**ADDENDUM NO. 2 TO CONTRACT DOCUMENTS
RICHARD B. RUSSELL REGIONAL AIRPORT
TAXIWAY BRAVO WEST REOCATION
(FLOYD COUNTY BID NO. 26 - 022)**

**PRE-BID CONFERENCE MINUTES
TAXIWAY BRAVO WEST RELOCATION
RICHARD B. RUSSELL REGIONAL AIRPORT, FLOYD COUNTY, GEORGIA
(FLOYD COUNTY BID # 26-022)**

TAXIWAY BRAVO WEST RELOCATION
RICHARD B. RUSSELL REGIONAL AIRPORT
FLOYD COUNTY, GA

CD-103
SHEET 15 of 81

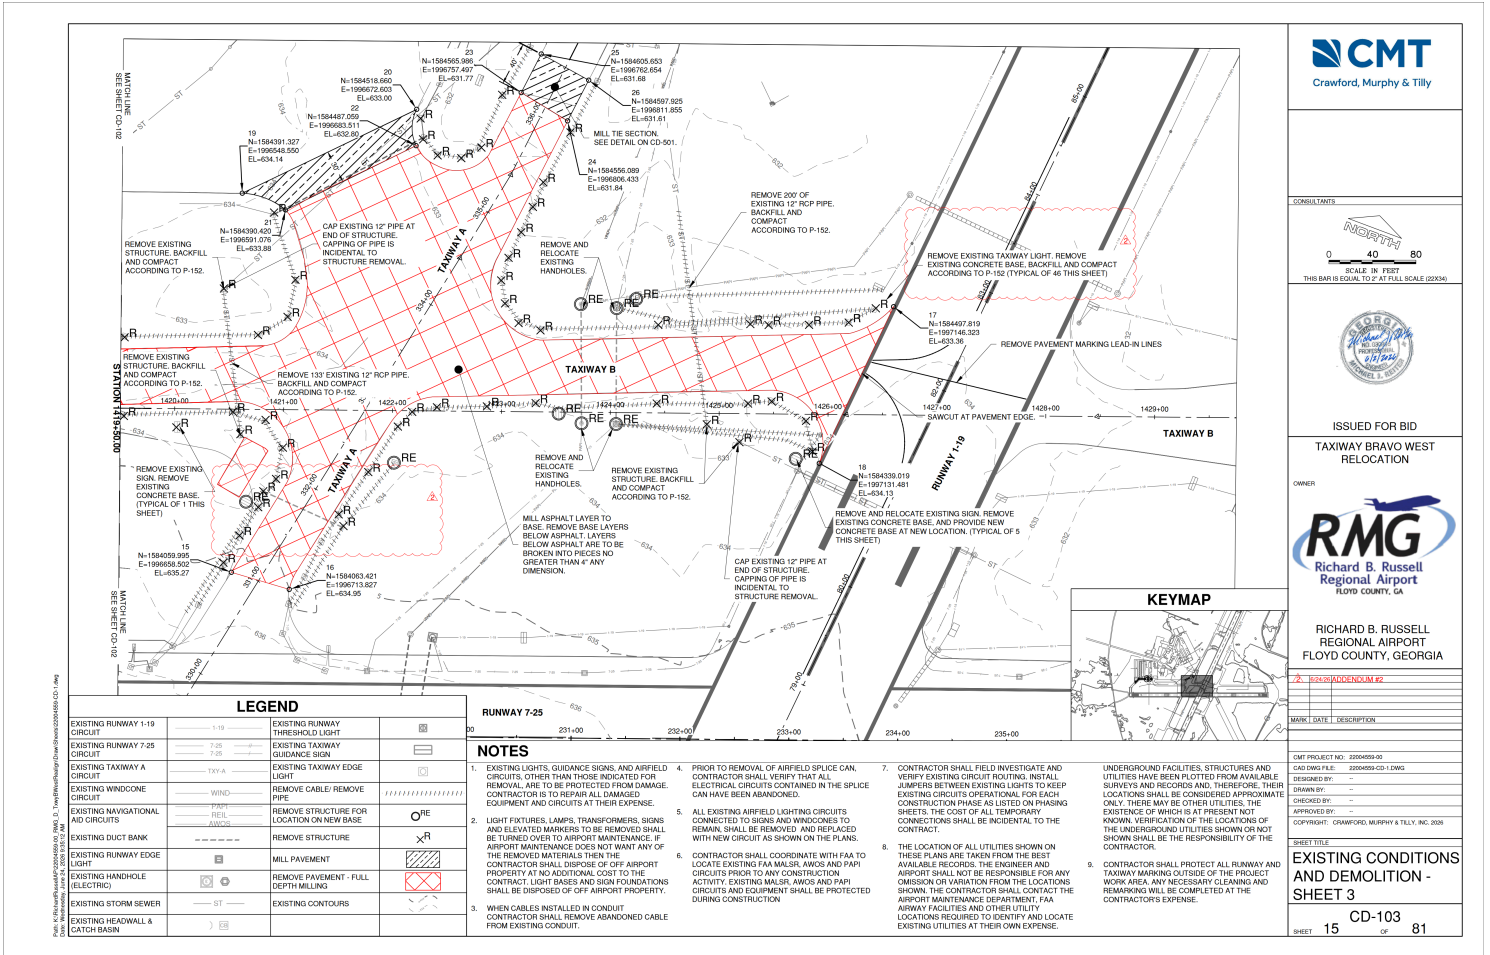
Revised Construction Drawings have been prepared to provide improved clarity, accuracy, and consistency. These revisions/clarifications are primarily associated with electrical demolition.

Demolition Sheet (CD-103) has been revised to clarify the quantities associated with Pay items 61, 62 and 65.
